TECHNICAL NOTE TN-1113
New TM8100 Raywood
Firmware Version 2417A124

15th November 2005

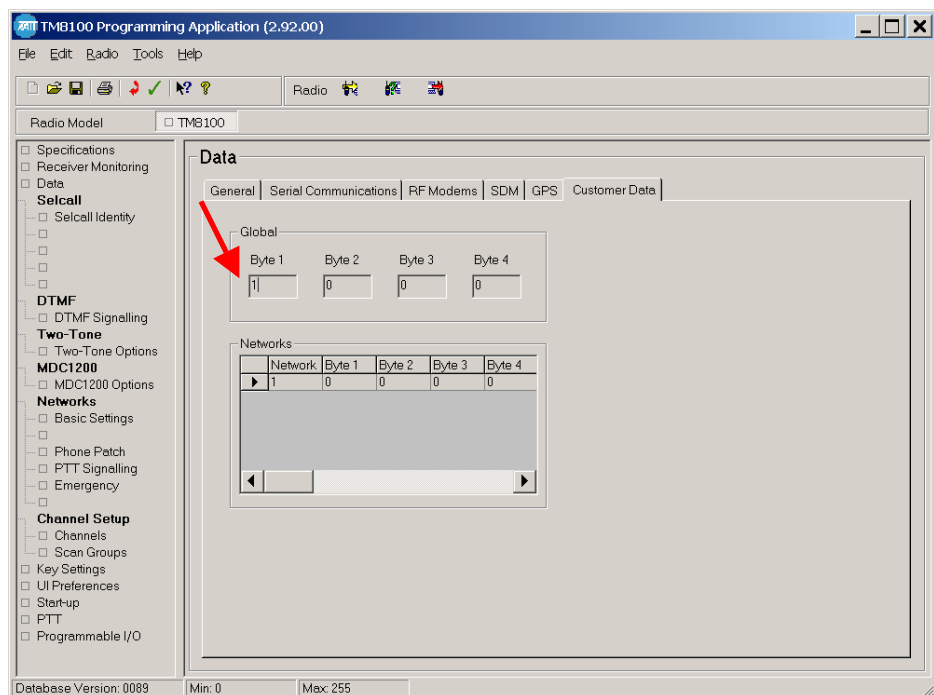
V24 offers the programmer the ability to invert the RX Audio line polarity. To achieve this, open the TM8100 Programming Application, read the current radio personality and go to - DATA > CUSTOMER DATA. In the field labelled "Byte 1" (indicated in the screen shot below), simply enter in the number '1', then program the radio unit.
